# MARKET STREET SUBWAY STATIONS

A SPUR REPORT - DECEMBER 1964

A SPUR committee reviewed the preliminary proposals for Market Street as reflected in Sketch I. Five Market Street stations are planned. Two serve the Municipal Railway Company; three accommodate both Rapid Transit and Muni. They are about 700 feet long, and are spaced 2000 to 2500 feet apart along the center of the street.

SKETCH

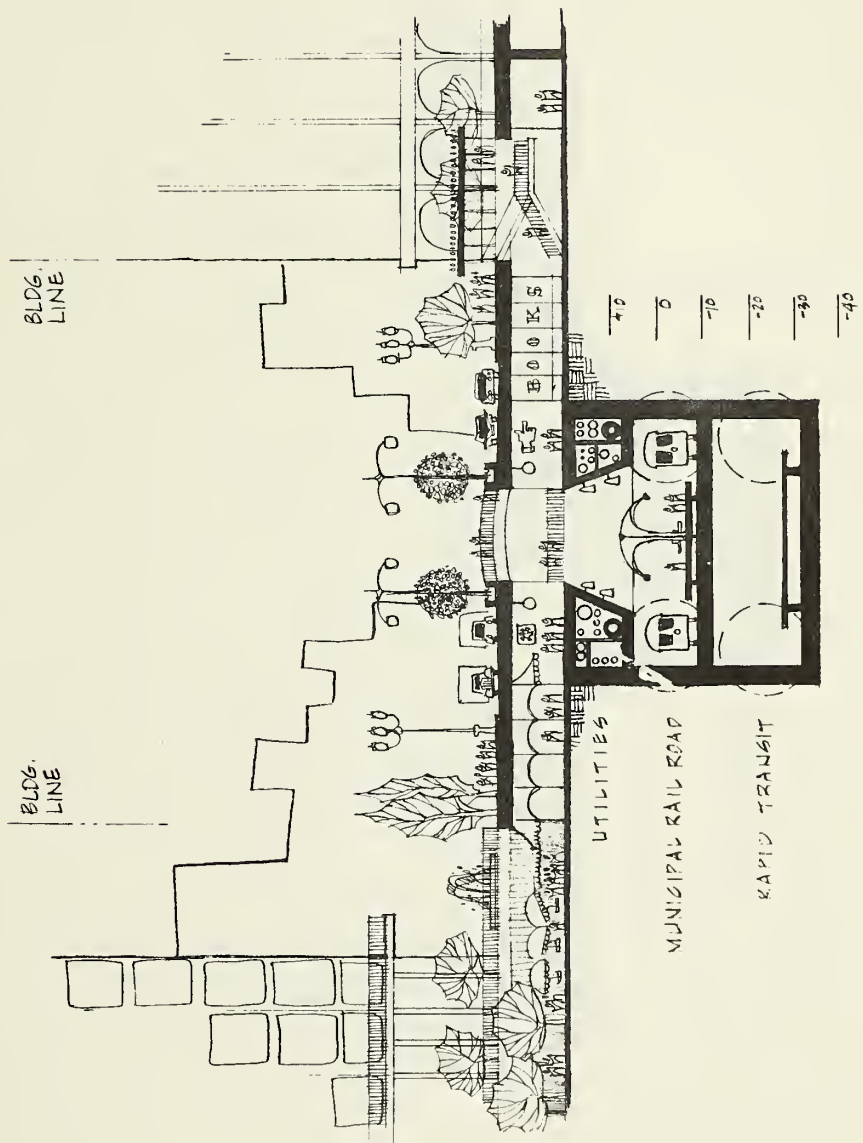
As shown in Sketch I, the stations have three levels - the Concourse or ticketing level, below it the Muni level, and deepest, the Rapid Transit level. The "roof" of the station in the current design is below the existing layer of street utilities, with the result that the floor of the Concourse is some 28 or 29 feet below the street, and the Rapid Transit platform is about 60 feet underground. Vertical circulation from street to Concourse is by escalator, except where traffic volume would not justify the additional expense over stairways. The Concourse is connected by escalator to the lower levels.

Not incorporated in the Sketch I design is the 1962 suggestion that the Concourse should be opened to the sky and related to store basements when streetcar service is relocated underground. Instead the Concourse floor is indicated at approximately 14 to 16 feet below existing basements.. This was based on the assumption that maintaining utilities in place in the center of the street was necessary.

scheme (Sketch I) is adaptable only by awkward appendages to the three-story basic box. It seems necessary to develop a scheme in which the Concourse may be varied to suit street-level needs, with relative independence from an unvaried two-level box below. Sketches II, III, and IV, and the study model show such possibilities.

IV

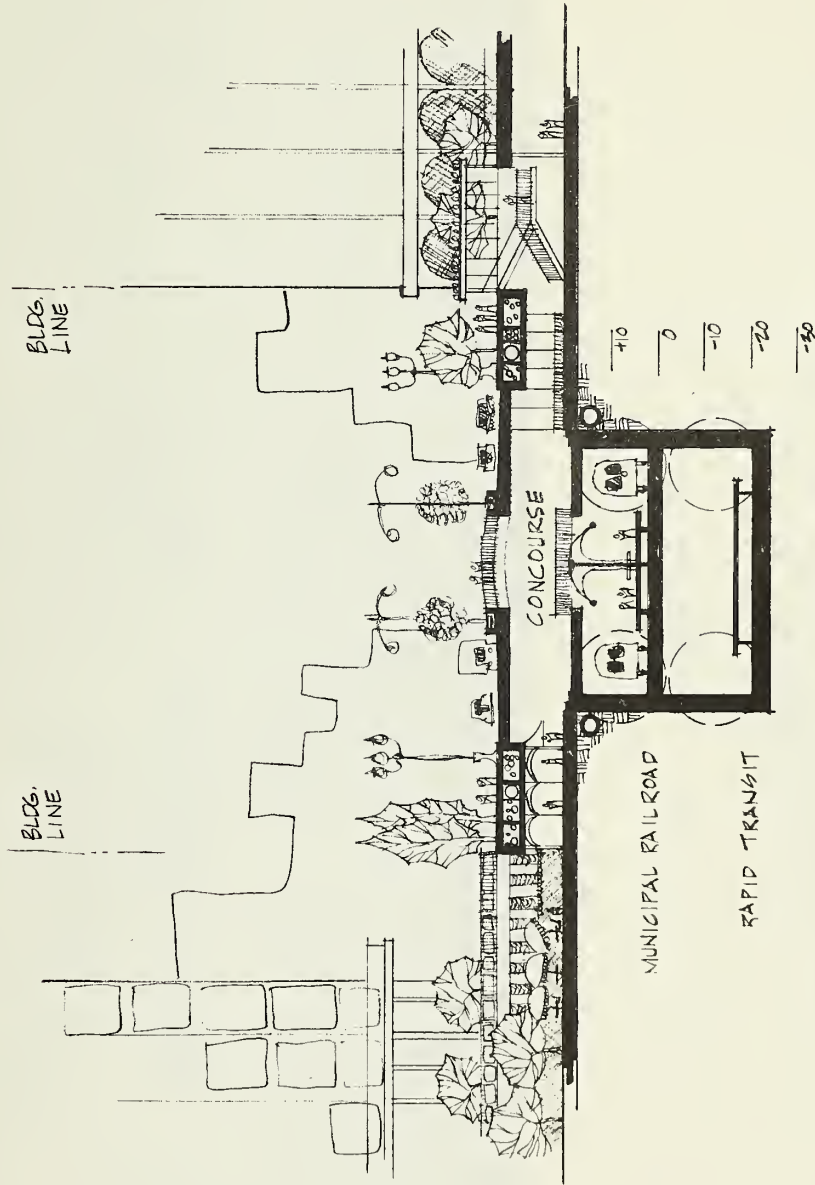
What stands in the way of this concept? Utility lines under the street would have to be relocated. They could be grouped more compactly along the center-line of the street (Sketch III), or placed in concrete ducts under the sidewalk (Sketch IV), or, as shown in Sketch II and the model, under the pedestrian mezzanine. There could also be any combination of these, determined by the particular situation at each station. The under-sidewalk location, if found feasible, would permit a reduction of about 14 feet in the depth of the station, effecting enormous savings in construction cost. It could also greatly facilitate excavation of the station areas. Concrete ducts for pipes and conduits offer the bonus factors of longer life, fewer repairs, earthquake protection, and easy access for changes. However, the problem of possible gas and water leaks would have to be thought out.
